UNITED STATES PATENT AND TRADEMARK OFFICE

APPLICATION NO.	FILING DATE	FIRST NAMED INVENTOR	ATTORNEY DOCKET NO.	CONFIRMATION NO.
10/563,505	01/05/2006	Wilhelmus Christianus Maria Lohbeck	TS6437US	8251
23632	7590	09/20/2007		
SHELL OIL COMPANY P O BOX 2463 HOUSTON, TX 772522463			EXAMINER HARCOURT, BRAD	
			ART UNIT 3672	PAPER NUMBER
			MAIL DATE 09/20/2007	DELIVERY MODE PAPER

Office Action Summary	Application No. 10/563,505	Applicant(s) LOHBECK ET AL.	
	Examiner Brad Harcourt	Art Unit 3672

DETAILED ACTION

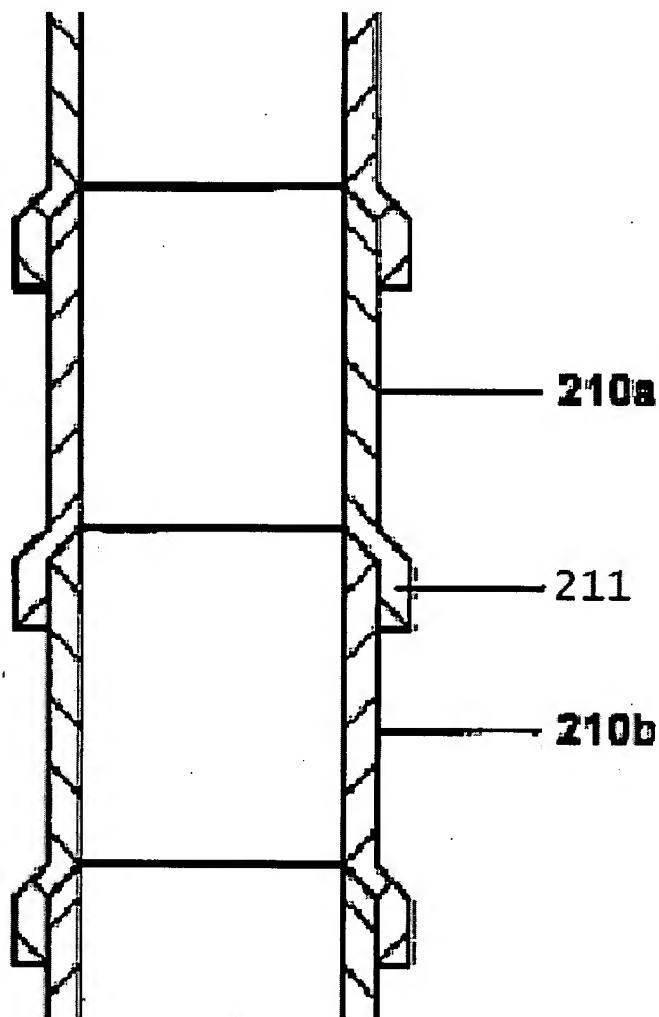
Kendziora discloses a method and apparatus (see figure below) for expanding a tubular comprising first tubing section 210a, second tubing section 211; and expandable sleeve 210b. In operation, using expander 905; first and second tubing sections 210a and 211 are expanded; sleeve 210b is placed adjacent to second tubing section 211; sleeve 210b is expanded to the same diameter of tubing section 210a, and second tubing section 211 is expanded to a diameter the sum of first section 210a and twice the wall thickness of sleeve 210b.

Kendziora discloses all of the limitations of the above claims with the exception of retrieving an expandable sleeve. Harrall discloses a method and apparatus for expanding tubing comprising using a rotary expansion tool 526 to sever and remove expandable sleeve 565 (Fig. 13D). It would have been obvious to a person having ordinary skill in the art at the time of the invention to include a method of removing a

sleeve or other tubular from the wellbore in the system of Kendziora in view of Harrall to provide a means of disassembling a casing string if it should be required.
